AGENDA – Planning Commission Meeting

**PLANNING COMMISSION
Staff Report**

Riverview Plaza & Townhomes: Rezone and Concept Plan

River View Plaza & River View Townhomes

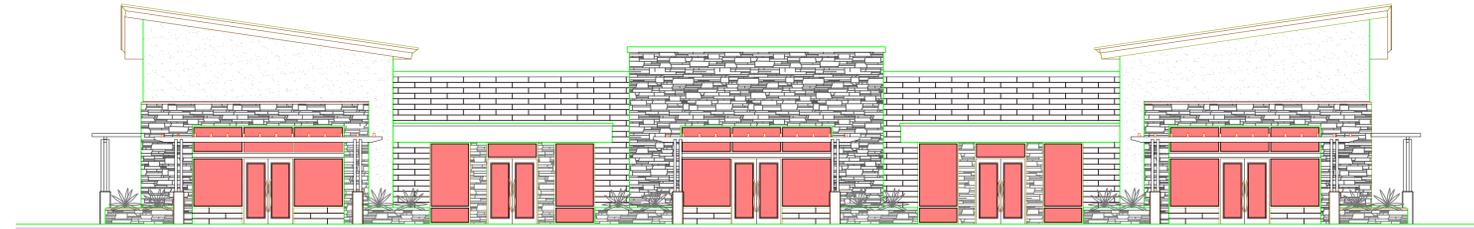
The proposed concept plan contains several outstanding redline corrections. Instead of resubmitting a concept plan multiple times, staff typically provides the applicant a first review and allows the applicant the choice of moving on in the development process or resubmitting until the applicant is comfortable with the level of corrections needed. In this case, two full reviews and one supplemental review have been made of the concept plan and rezone. The current concept plan is contained in Exhibit 4.

The Planning Review Checklist was used and identifies areas the concept plan is deficient regarding Code requirements. A few key items are listed below but the list is not exhaustive. Full compliant checklist will be used at the time of site plan approval provided the rezone is approved by the City Council.

- The curve of Riverside must be modified to meet Engineering requirements.

- UDOT may require a right-in/right-out access in anticipation of potential future median.
- A few remaining contradictory or outdated pieces of information must be harmonized (e.g. County acreage vs. surveyed, company ownership records, etc.)
- Overall density appears to comply with the standards of the Mixed-Use Zone.
- Riverbank stabilization, open space improvements, and other site plan specific items will be reviewed for completeness and code compliance through the site plan and subdivision processes.

1. All requirements of the City Engineer shall be met, including but not limited to those in the attached report.
2. All requirements of UDOT concerning access shall be met.
3. Additional items will require further review at the subdivision/site plan review level.
4. The plans shall comply with all Code requirements.
5. Any comments providing direction from the Planning Commission: _____
